PLANNING, ZONING, & BUILDING DEPARTMENT
PZ&B Staff Combination Memorandum: Architectural Commission and Town Council

SUBJECT: ARC-23-122 (ZON-23-093) 241 JUNGLE RD (COMBO)

MEETING: SEPTEMBER 27, 2023 ARCOM
OCTOBER 11, 2023 TC

ARC-23-122 (ZON-23-093) 241 JUNGLE RD (COMBO). The applicant, 241 Jungle Rd Trust, has filed an application requesting Architectural Commission review and approval for the installation of a new generator and site screening walls and gate including a variance to exceed the maximum screening wall height. This is a combination project that shall also be reviewed by Town Council as it pertains to zoning relief/approval.

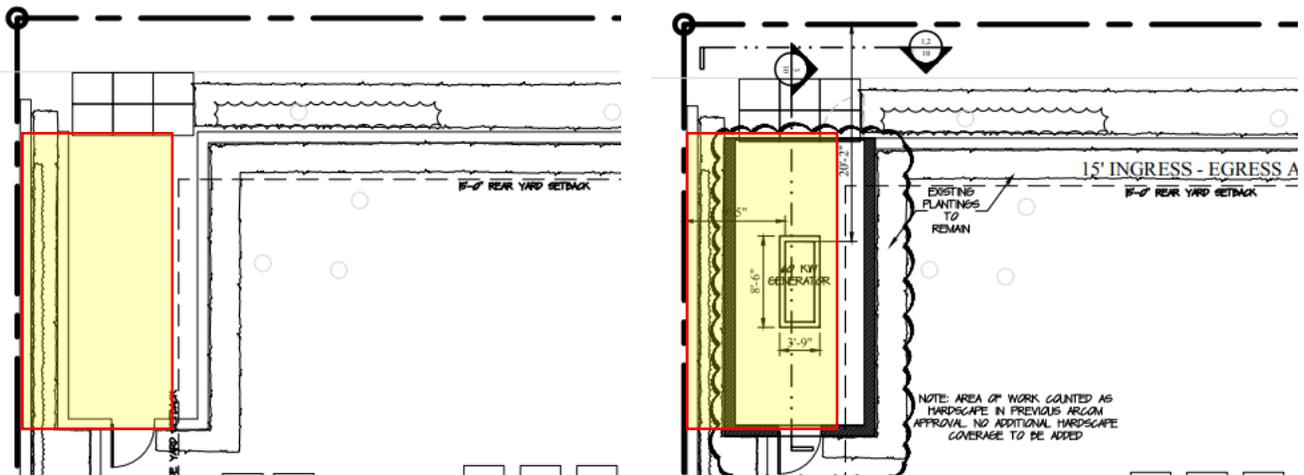
- **VARIANCE 1:** Sec 134-1669 A variance to exceed the maximum wall height by 1' in

order to install a wall at 8' where 7' is permitted within a required yard.

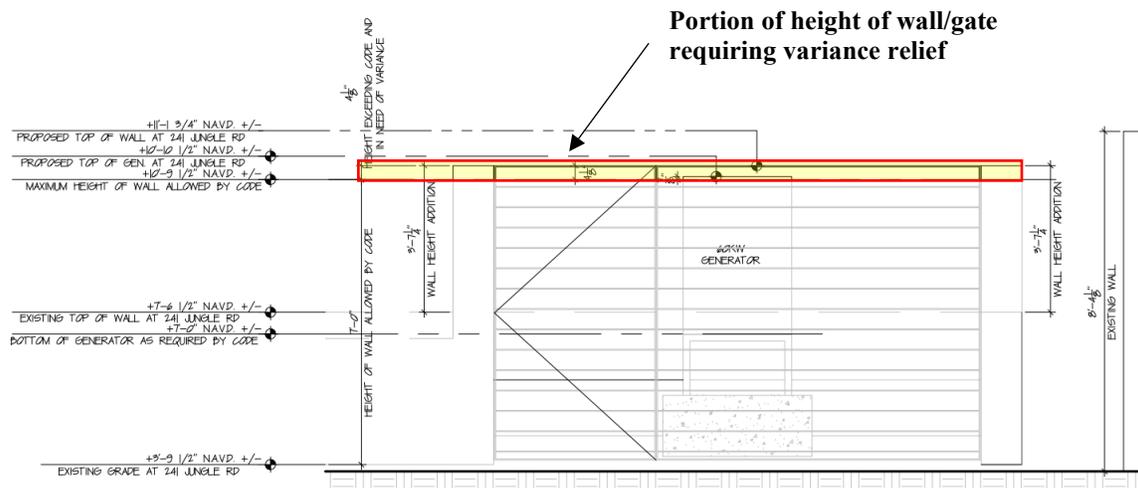
The subject parcel is very low, with a crown-of-road just under 3.41' NAVD. FEMA requirements mandate that new equipment be installed at minimum flood elevation, which is 7' NAVD. In doing so, the equipment must be physically raised off grade to the minimum requirement. Equipment

located within yard areas are required to be screened by masonry walls as high as the equipment but are not permitted to exceed maximum wall heights. If the applicants chose to install a masonry screening wall to the top of the equipment, they would also need a variance to exceed wall heights within a side and front yard to 8' in height in lieu of the 7' permitted. The yard section diagrams below illustrate the portion of the walls/gate that exceed the height allowance in the side street yard.
